PERMIT

SEWAGE DISPOSAL SYSTEM
HOWARD COUNTY HEALTH DEPARTMENT
BUREAU OF ENVIRONMENTAL HEALTH
410-313-2640

UBDIVISION Paternal Gift Farm LOT NUMBER 11 ADDRESS 13517 Paternal Gift Drive

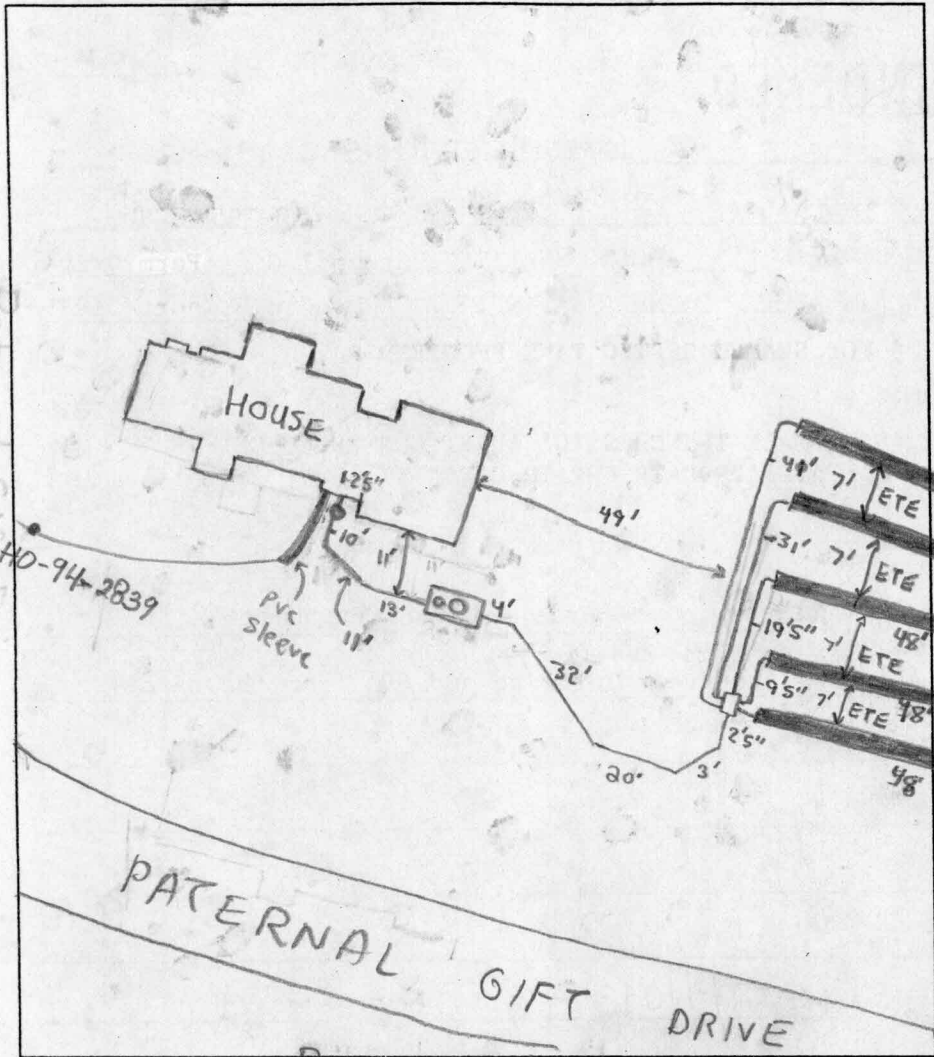
PRE-CONSTRUCTION INSPECTION: 5/30/01 - LAYOUT CANCELLED - AREA NOT STAKED - (SRK)

5/31/01 Contour different than on plan. To install 5-48' trenches at highest part of easement. (RB)

INSPECTION COMMENTS: 6/1/01 - ON TO COVER ALL WORK, HOUSE CONN. STILL NEEDED

(SRK) 7/10/01 - HOUSE CONN. MADE - (SRK)
